Requested Filter Element Replacement in Connection with DMTL Replacement

Models	Model Year	Model Type	VIN Range	Vehicle-Specific Equipment
Panamera	2017 - 2020	971	N/A	N/A

Figure 1 - Filter element requested for replacement with the DMTL

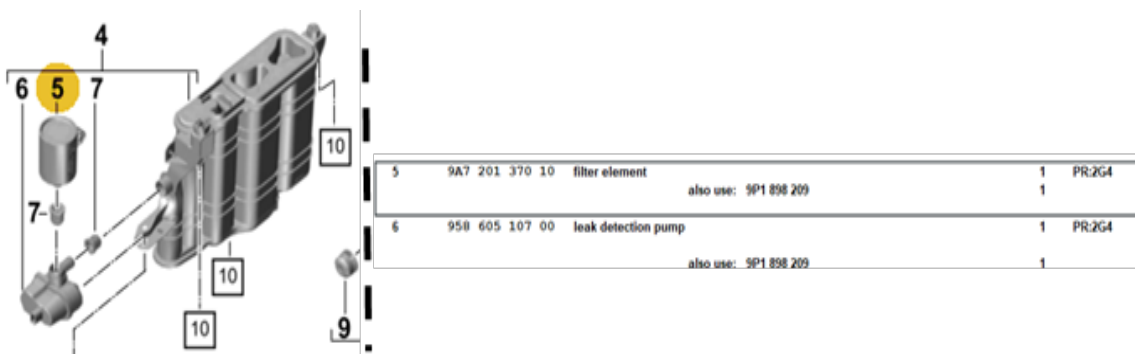
In the same PQIS entry and warranty request to replace the DMTL to properly repair the vehicle, please replace the filter element (Part 5) shown below. (Only 1 "repair kit for the evaporative emission canister" 9P1 898 209 is necessary.)
